SVS-03-09  
1/30/2009**TO: ALL ISUZU DISTRIBUTOR & DEALER SERVICE & PARTS PERSONNEL****SUBJECT: ADDITION OF INJECTION TIMING MARKS ON FLYWHEELS OF 3CD1T AND 3CE1 ENGINES**

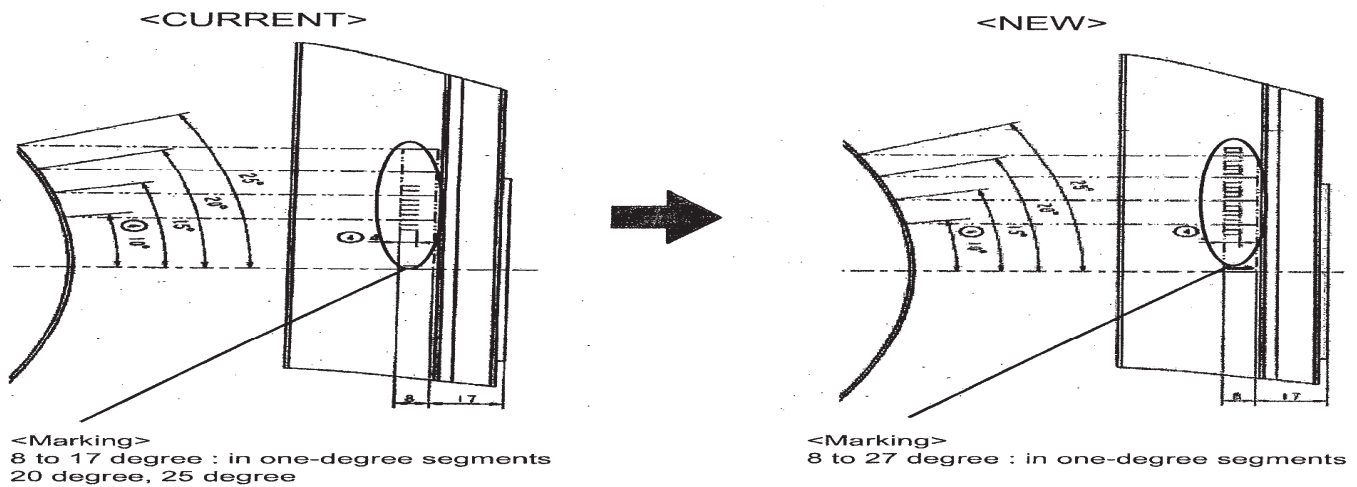
Isuzu Motors Limited has implemented a design change to the flywheel injection timing mark. The current markings include a range of 8 to 17 degrees in one-degree increments, plus a 20 and 25 degree mark. The **NEW** markings will include a range from **8 to 27 degrees** in one-degree increments.
